**Subject: Addendum to the Work Plan for Soil and Groundwater Investigation,
17715 Mission Boulevard, Hayward, California**

September 10, 2003
Project 03-103.06

Sierra Environmental, Inc. (Sierra) has prepared this addendum to our May 27, 2003 work plan in response to the comments presented by Mr. Scott Seery of the Alameda County Environmental Health Care Services Agency (ACHCS) in his August 12, 2003 letter. As requested by Mr. Seery, Sierra has extensively revised the original scope of work and included the following additional tasks in this addendum to the work plan.

Expanded Sit Plan
Soil and Groundwater Investigation
ABE Petroleum LLC

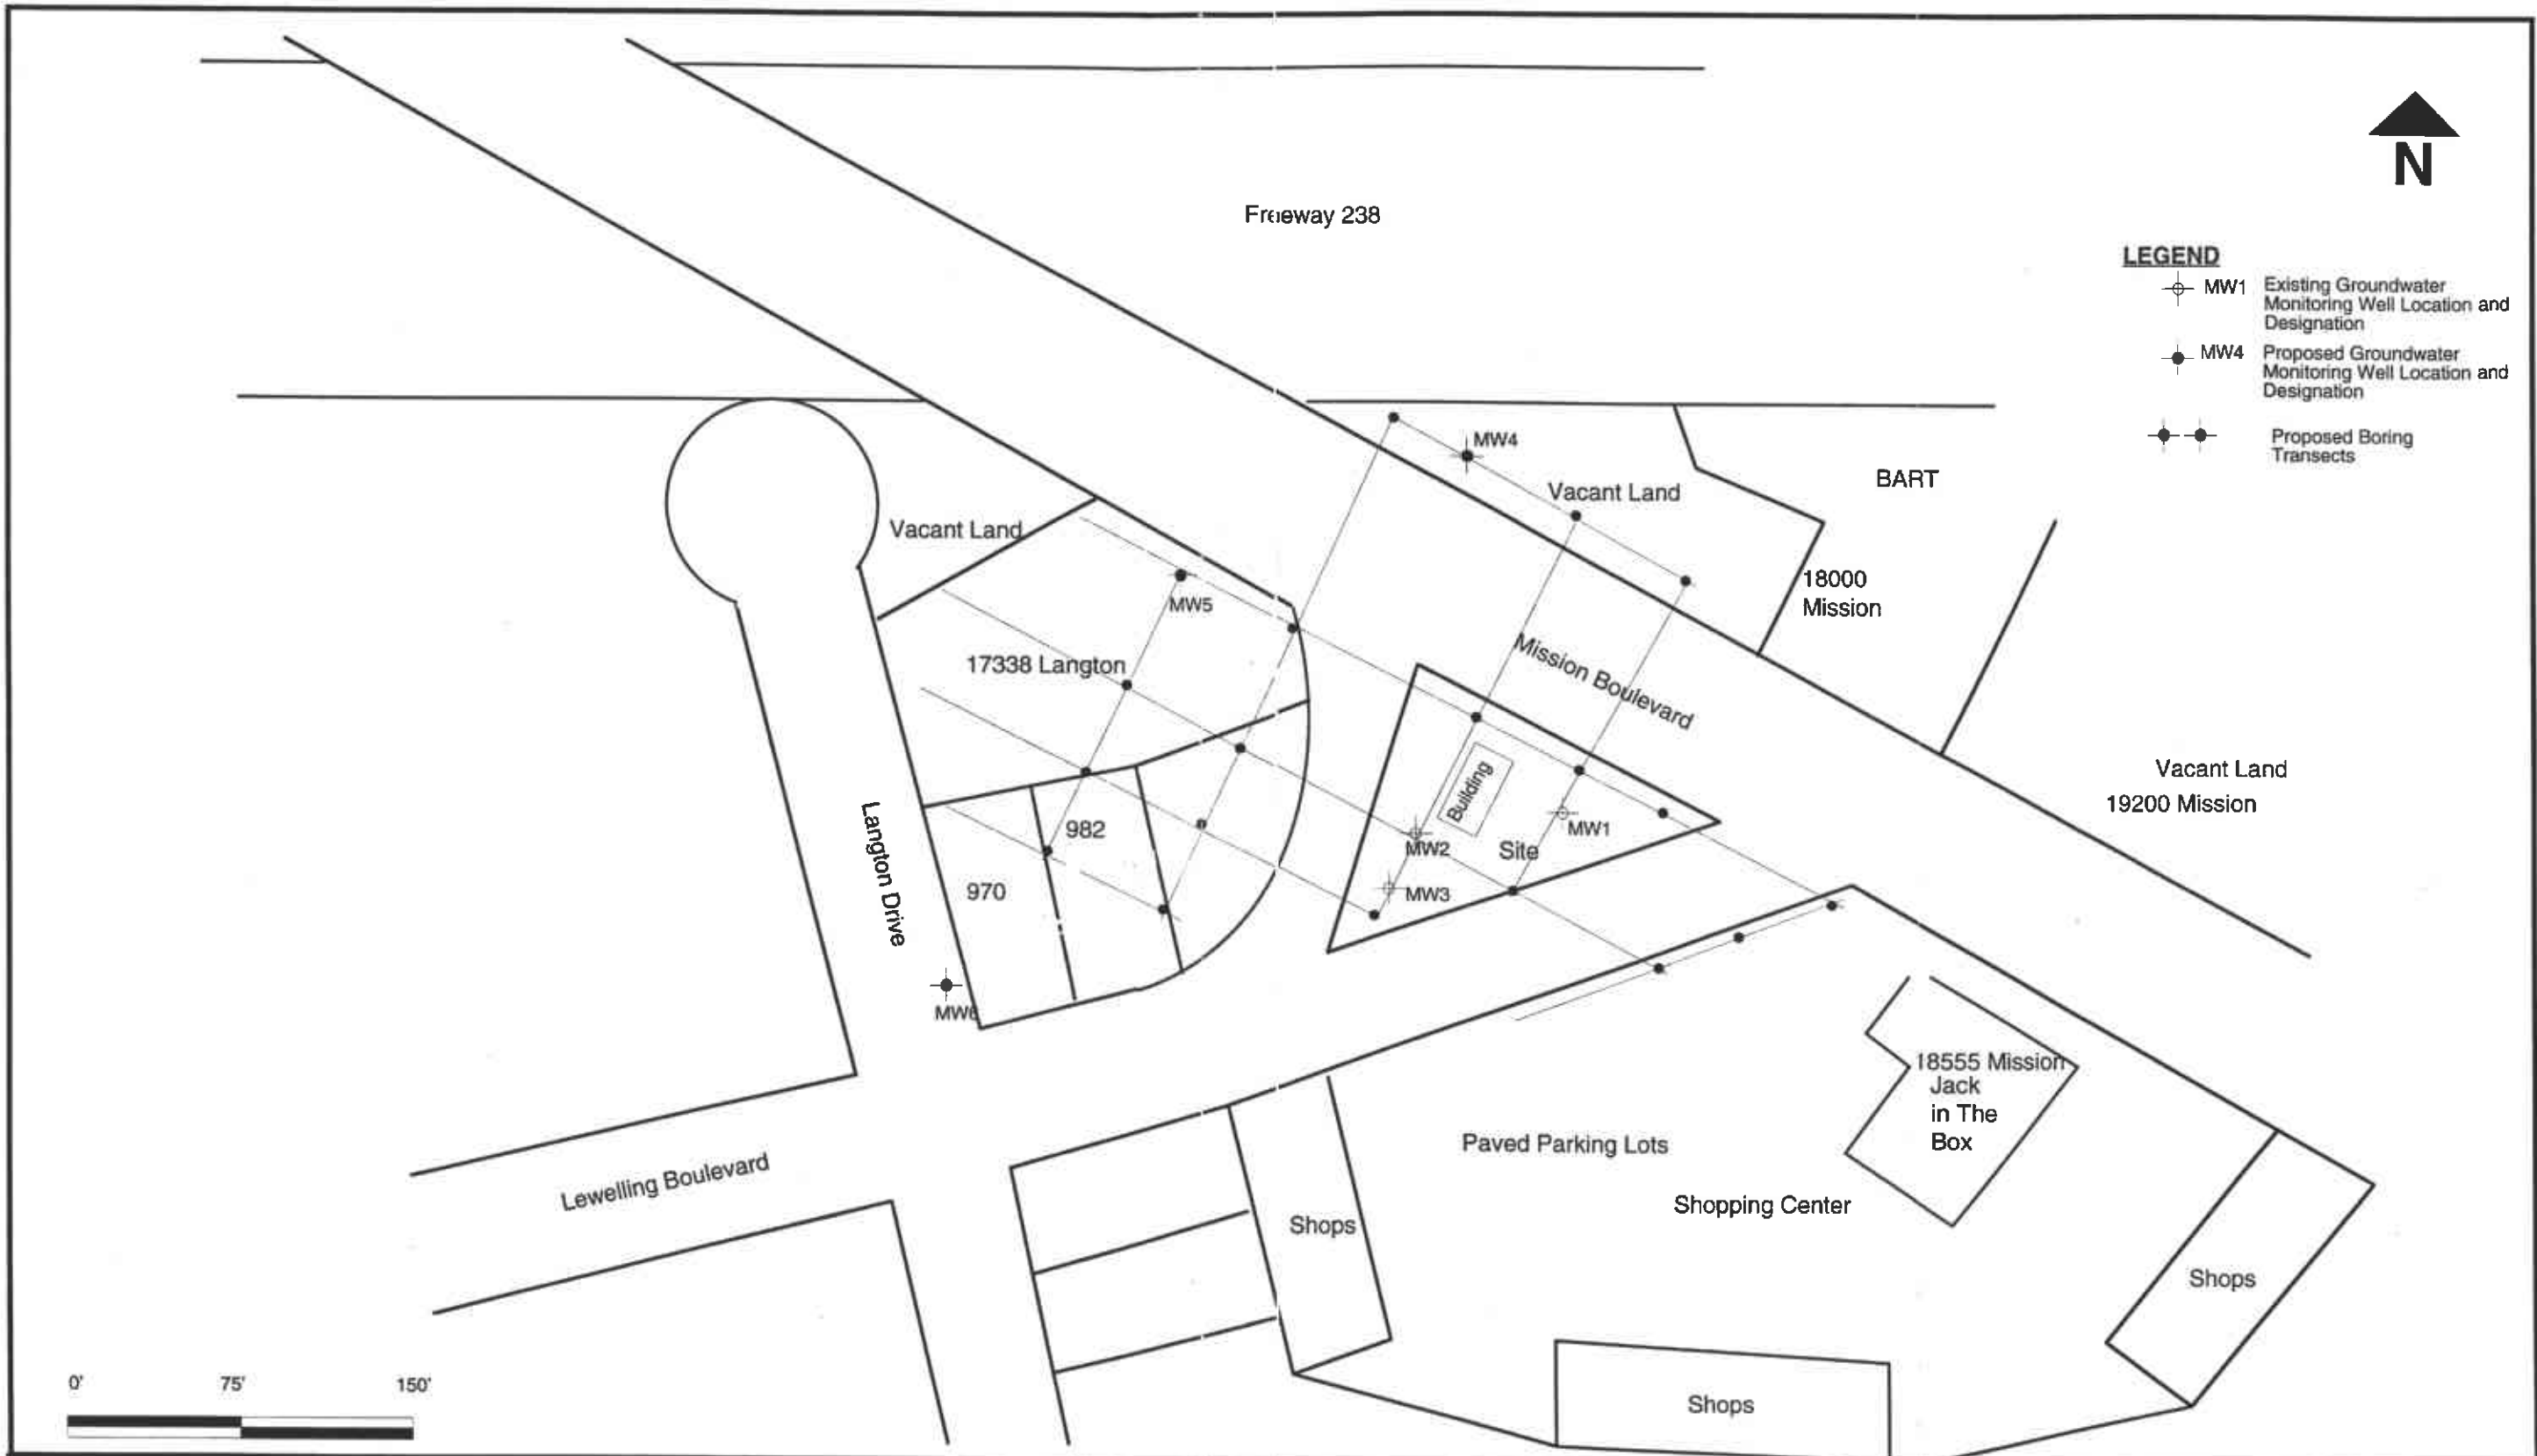
As requested by ACHCS, we have designed a tentative grid of boring transects showing proposed locations for 18 exploratory borings (Figure 1). Because the groundwater flow direction is uncertain, Mission Boulevard is the principal feature governing the orientation of the grid, but the grid could be rotated by several degrees if necessary after Task 1 has been completed to more closely match the flow direction. The average spacing between borings is about 35 feet, except where the transects cross various streets. Several borings would be located on private properties, and it would be necessary to secure permission from the various property owners before drilling could be performed. It might be necessary to adjust some locations if property owners and/or access restrictions prevent the grid from being drilled as shown. The drilling program would encompass the following subtasks:

To better characterize the vertical stratigraphy, we propose to continuously sample 3 of the 18 proposed borings. One of these borings will be located on the site, another will be located in the vacant lot north of Mission Boulevard, and the third will be located at the most convenient location south of MW5 (Figure 1). If sufficient room is available, a cone-penetrometer rig will be used, but if access is limited, either a conventional hollow-stem auger rig or a Geoprobe- rig may be required. This will be determined in consultation with potential drilling subcontractors, after property owners have been contacted for permission to drill. The core samples will be preserved in labeled core boxes for later detailed description and photography by a registered geologist.
